M.I.L. "ON" DTC P043E, P043F, P2401, P2402, and P2419

Service Category Engine/Hybrid System

Section Engine Control

YEAR(S)	MODEL(S)	ADDITIONAL INFORMATION
2006 – 2009	RAV4

Figure 1.

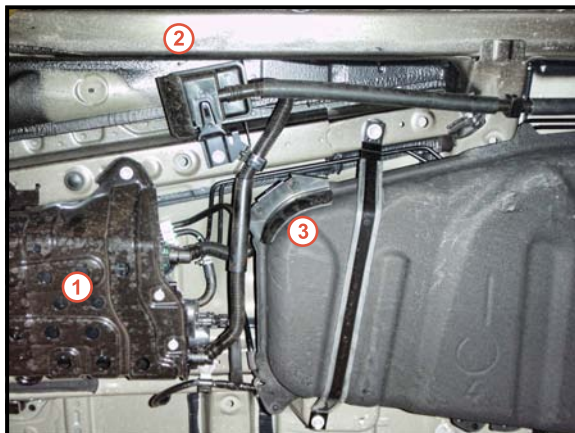
2. Replace the charcoal canister and charcoal canister filter if any water or debris is noted within the EVAP system.
3. Remove and discard the No. 2 fuel tank protector.

1	Charcoal Canister Assembly
2	Charcoal Canister Filter Sub-Assembly
3	No. 2 Fuel Tank Protector

Figure 2.

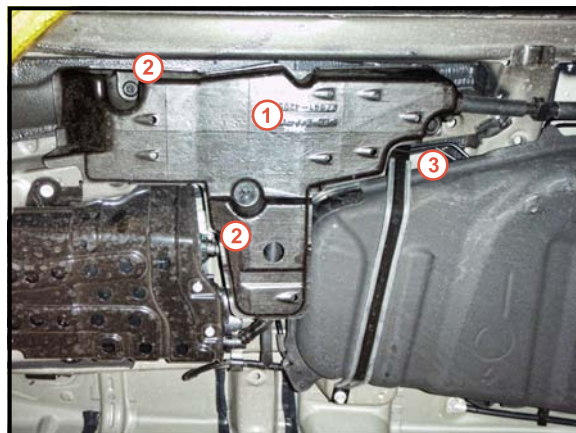
4. Install the fuel tank protector.

1	Fuel Tank Protector
2	Clips (Included on Fuel Tank Protector)
3	Clip (Part Number 90467-07201)
